# SERVICE BULLETIN No.1165

<b>COACH MODEL</b>	: C2045
<b>BULLETIN TYPE</b>	: Product Improvement
<b>MANUAL &amp; SECTION</b>	: Maintenance Manual: N/A Spare Parts Manual: Section 7410 – Luggage racks
<b>PARTS BOOK REVISION</b>	: Yes
<b>DATE</b>	: December 1, 2005
<b>SUBJECT</b>	: <b>Parcel rack door installation</b>
<b>TERMS &amp; CONDITIONS</b>	: No claims will be accepted with reference to this Bulletin.

**Figure 1: New parcel rack door installation**

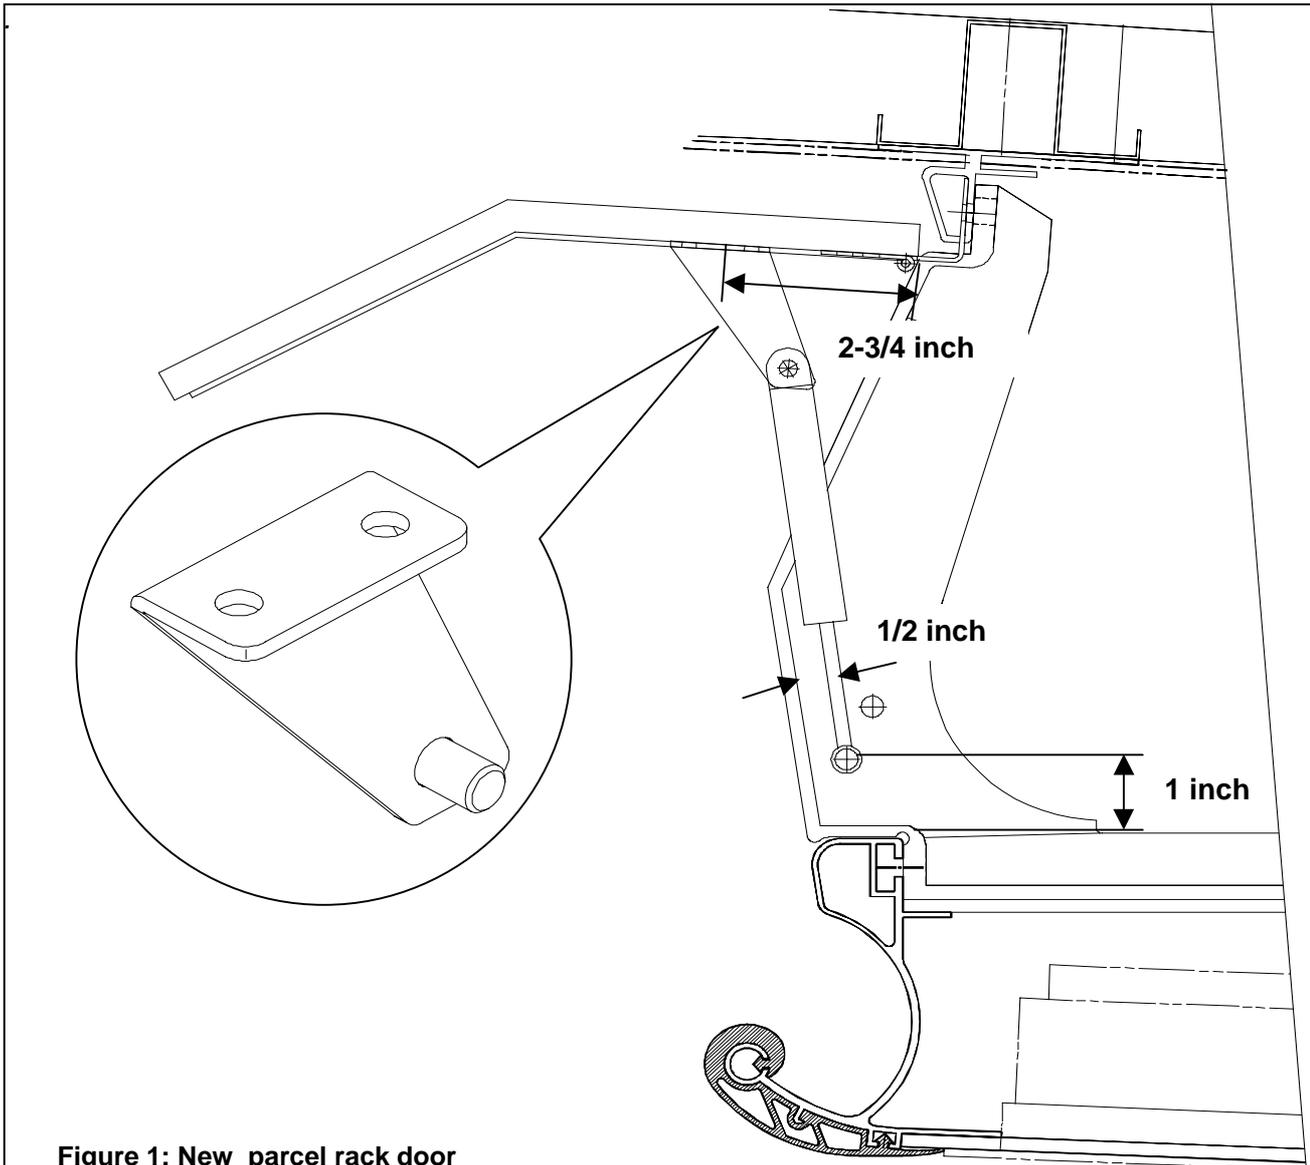
1. The installation of the optional parcel rack doors on C2000 Series coaches has been changed to provide improved retention. The new doors feature a redesigned and relocated gas strut mounting bracket and a larger ABS liner with a glued-in aluminum back-up plate to accept the mounting screws (see Figures 1).
2. In the interest of improved service life, the procedure in this Bulletin shows a revised installation method for old-style parcel rack doors, fitted to coaches in the field.

**Figure 3 (left): Gas strut parallel to parcel rack post**  
**Figure 4 (below): Bracket to long side distance**

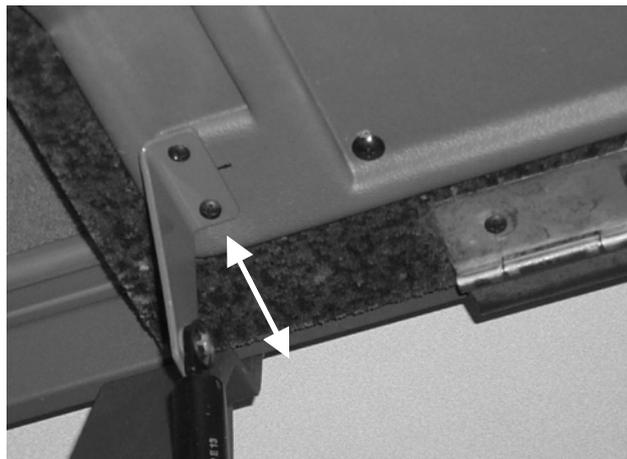
- 1) Open the parcel rack door.
- 2) Undo and remove the two self-tapping screws securing the gas strut upper mounting bracket to the door.
- 3) Line-up the gas strut and mounting bracket so that they are parallel to the parcel rack post (see Figure 3). Make sure that the bracket is at the same distance from the long side of the door as per factory installation (see Figure 4). The bracket holes should match the screw holes.

- 4) If the bracket holes do not match the screw holes, mark the new position of bracket holes on the ABS liner with a prick punch.
- 5) Drill two 5/16 inch (8 mm) holes to accept the self-tapping nuts VH 10611107.
- 6) Install the self-tapping nuts. Secure hand tight.

- 7) Reinstall the gas strut mounting bracket with bolts VH 660284921 and lock washers VH 660636200. It may be necessary to remove some of the liner material to make the bracket base meet the panel dead flat. Tighten to a torque of 3 ft.lbf (4 Nm).
- 8) Check parcel rack door operation.
